RE: Cockle Bay Marine Structures Redevelopment – Response to Heritage Council's Comments

The NSW Heritage Council have provided comments to the Maritime Archaeology Statement of Heritage Impact (MASoHI) report in the form of six comments relevant to the MASoHI report that require a response (NSW Heritage Council document EF14/23309). This short report provides the responses to each point as part of the formal submission to Heritage Council's comments. The sixth comment in the Heritage Council submission regarding the listing of the exposed section of seawall is not directly relevant to the MASoHI and is not addressed in this short report.

**1956 West 2**

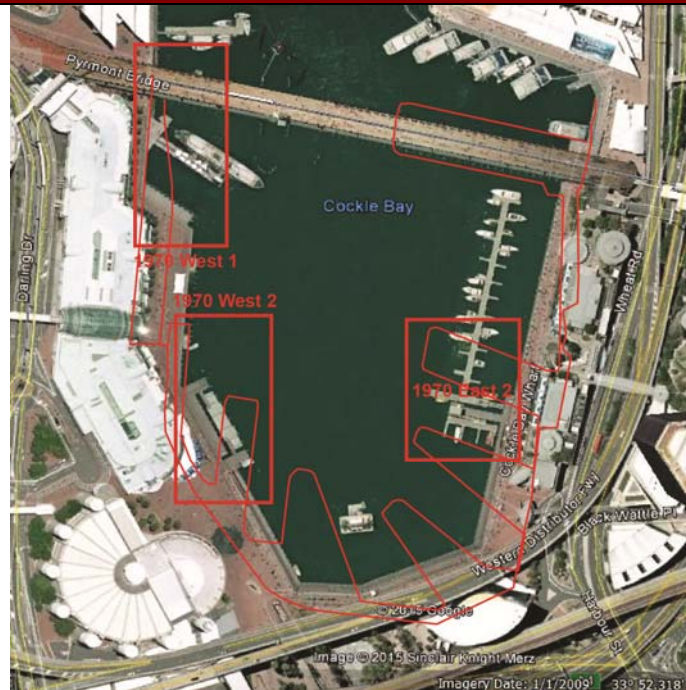
There are two groups of proposed piles that have the potential to impact on the footprint of two former wharves that are present in the 1956 plan of Cockle Bay. There are two piles present on the left hand side wharf directly on, or immediately adjacent to, this wharf.

There is also a group of proposed piles located at the southern end of the wharf located on the right-hand side of the image opposite. These include piles that are located within and immediately adjacent to the footprint of this wharf.

The piles located within the footprint of the former wharf have potential to impact on archaeological remains associated with the former structure, as well as potential remains associated with the use of the former wharf.

The remaining piles located immediately adjacent to the wharf may impact on potential archaeological remains associated with the use of the former wharf.
